045-0056-00

FIRMWARE UPDATE AND ROM RELIABILITY IMPROVEMENT

For TEKTRONIX® 7854 Oscilloscopes

Serial Numbers B010100 - B063172

Fig. 1. Locations of Microcircuits on ROM Circuit Board (A31).

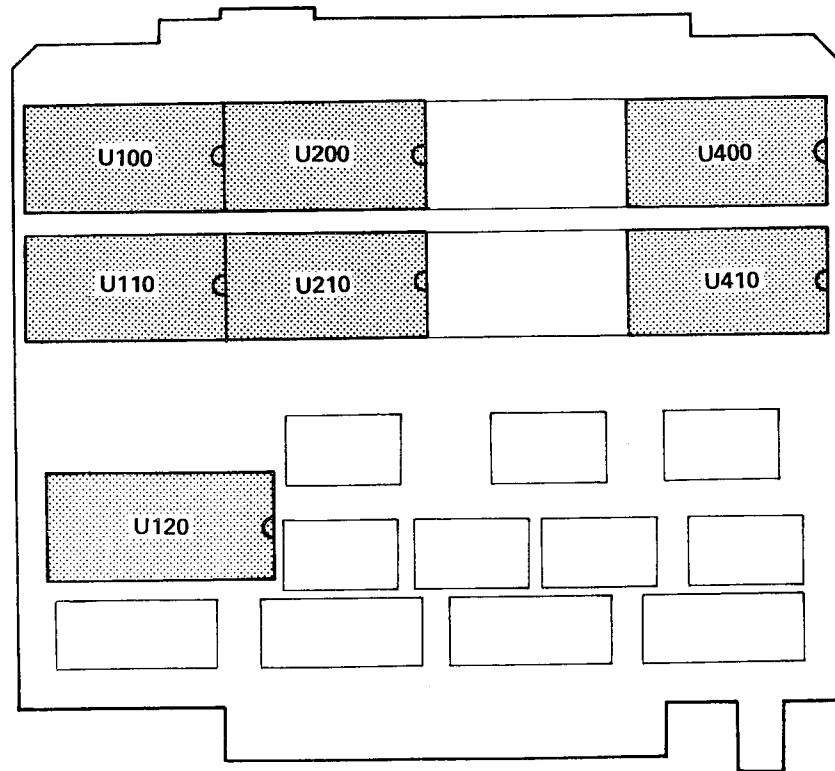
- () 5. Replace U100, U110, U120, U200, U210, U400, and U410 with the microcircuits provided in the kit. (Refer to Fig. 1 for locations of the microcircuits.)

This kit contains parts and instructions to update the firmware (U120, U400, and U410) to version 1.03. The new firmware ensures the GPIB commands, Serial Poll Disable (SPD) and Group Execute Trigger (GET), operate correctly. Also, the four ROM microcircuits, U100, U110, U200 and U210, are replaced with more reliable microcircuits.
